IN THE DRAWINGS

REMARKS

Amendments to the Drawings

FIG. 1

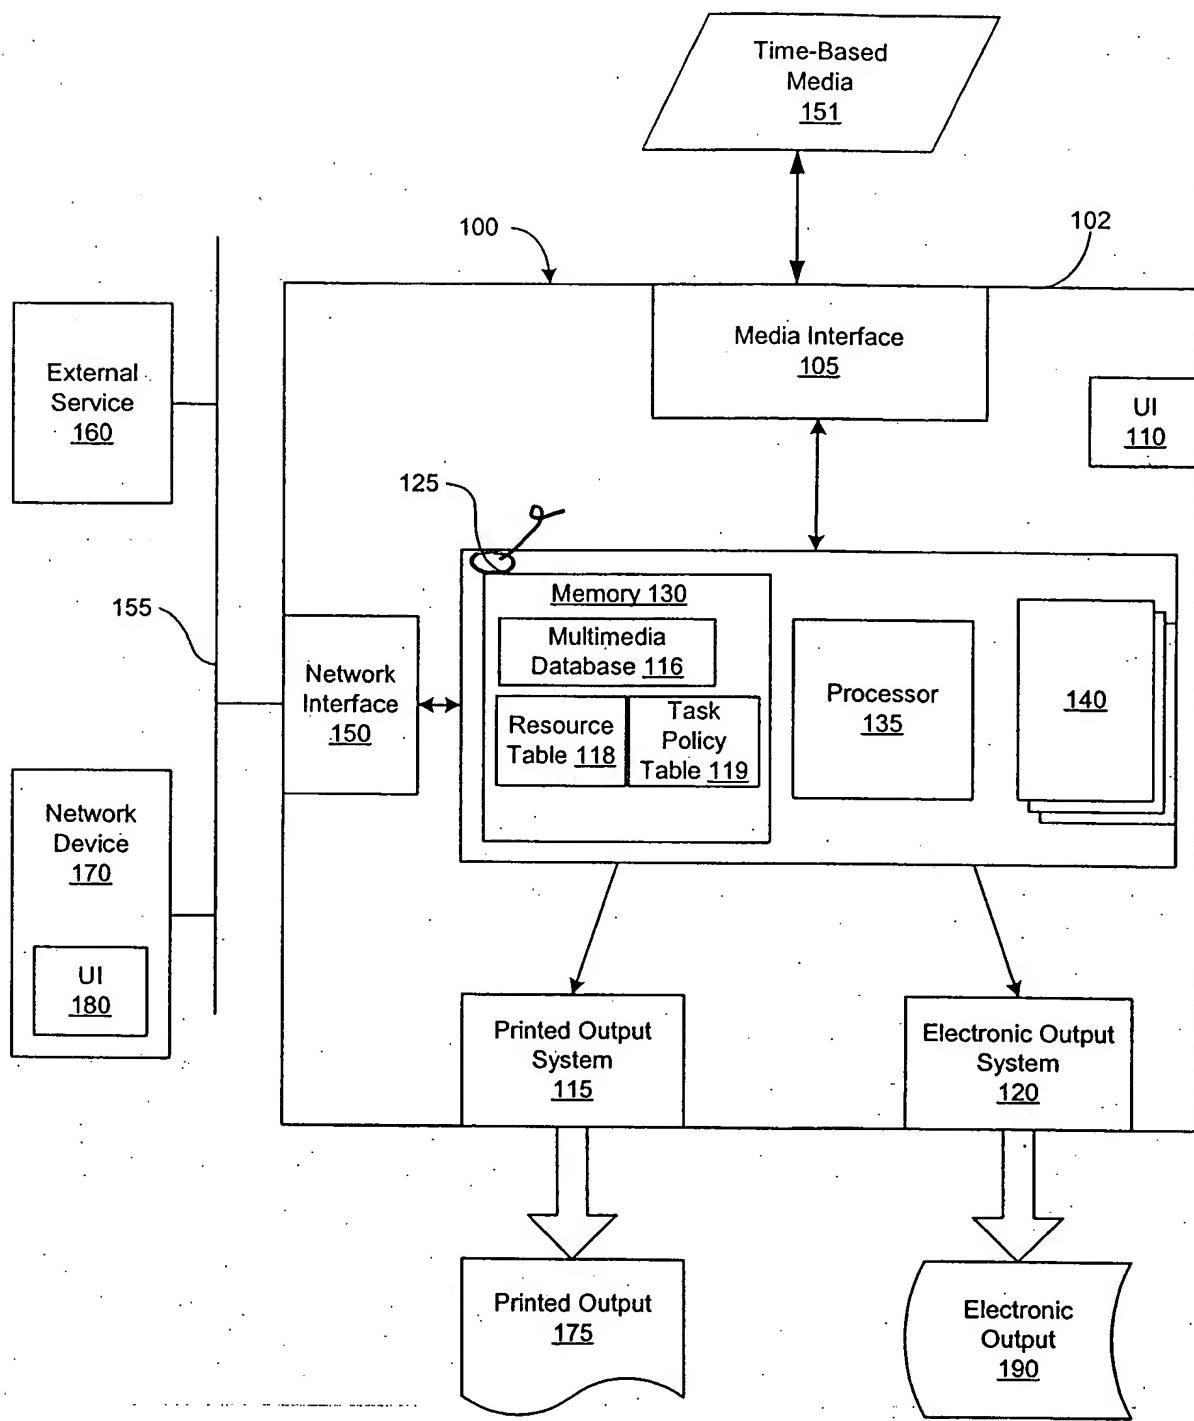
Applicants have amended Fig. 1 to remove an extraneous portion of the lead line attached to reference numeral 125. Rather than touching the box surrounding Memory 130, the lead line is intended to reference the outer box surrounding Memory 130, Processor 135, and Modules 140. This amendment is supported by the specification in paragraph [0032]. Applicants have amended

FIG. 2

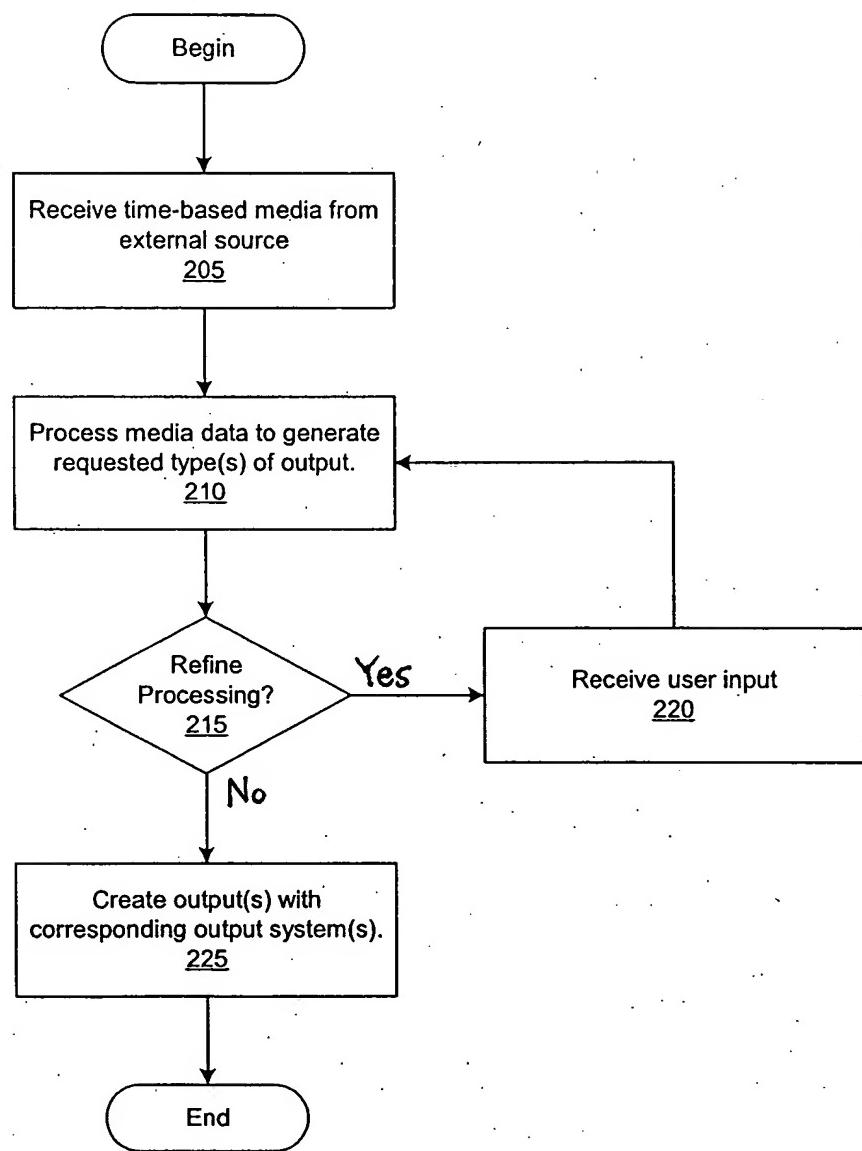
Fig. 2 to include “Yes” and “No” labels on decision element “Refine Processing? 215.” This amendment is supported by the specification in paragraph [0069]. Applicants have amended Fig. 4 to explicitly include a dashed outline and a reference numeral 115 to identify printed output system 115. This amendment is supported by Fig. 1 and paragraphs [0048]-[0050] of the specification. Applicants have amended Fig. 5 to explicitly include a dashed line and a reference numeral 120 to identify electronic output system 120. This amendment is supported by Fig. 1 and paragraphs [0051]-[0058] of the specification. Applicants have amended Fig. 15 to attach all lead lines to the proper boxes or arrows, to relocate reference numerals 1508 and 1514 to facilitate attaching their respective lead lines to the proper arrows, and to include reference numeral 1522 to identify a reply sent from the application server 1558 to the printer 1556. The addition of reference numeral 1522 is supported by paragraph [0084] of the specification.

Fig. 15

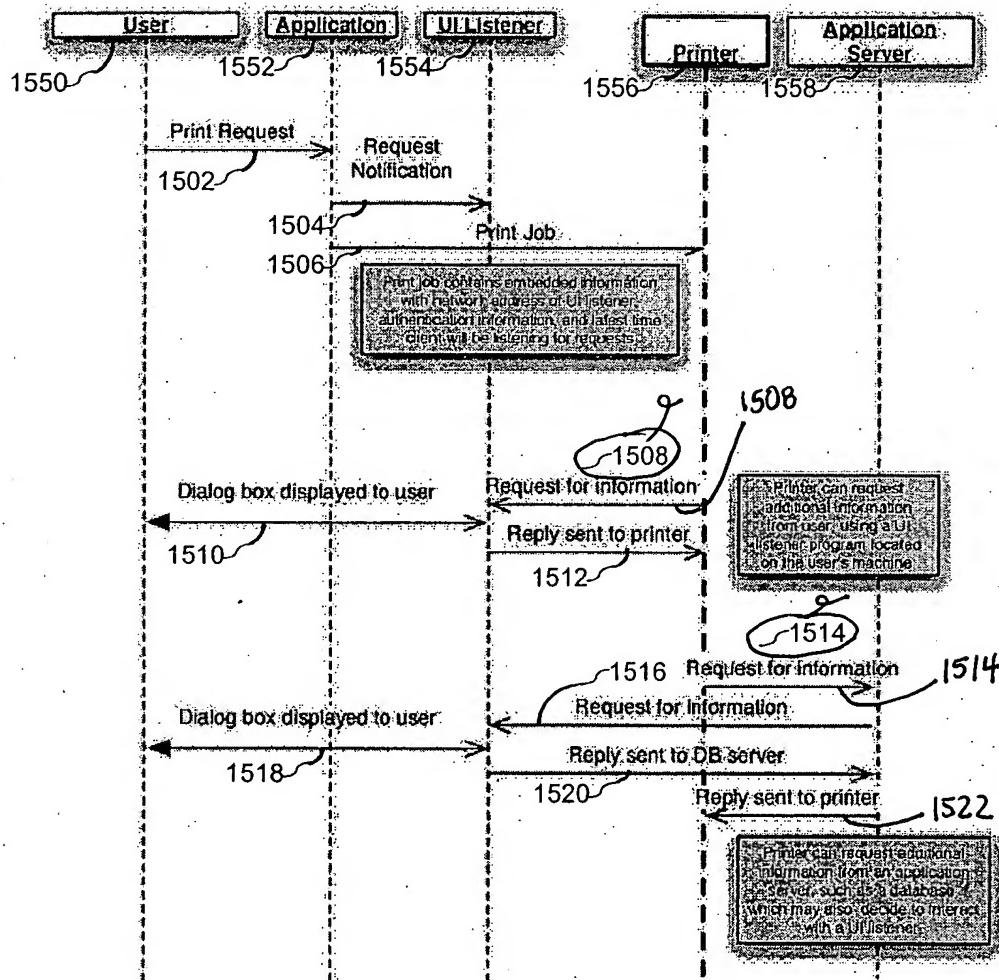
[0077] was amended to delete an extra reference numeral 1318, and to break a long sentence into several short sentences to improve clarity. Paragraph [0078] was additionally amended to relocate existing numerals 1404 and 1406 for clarity. Paragraph [0083] was additionally amended to relocate reference numeral 1504 for clarity, to correct typographical errors in identifying UI listener 1554, and to include reference numeral 1506, which was originally present in Fig. 15. Various amendments were made to paragraph [0084] to correct typographical and/or grammatical errors, to identify the printer with reference numeral 1556, to identify the UI listener with reference numeral 1554, to relocate reference numeral 1510 for clarity, to correct typographical errors in identifying user 1550, to correct typographical errors in identifying application server 1558, to include reference numeral 1520, which was included in original Fig. 15, and to include reference numeral 1522, which was added to Fig. 15 by amendment.
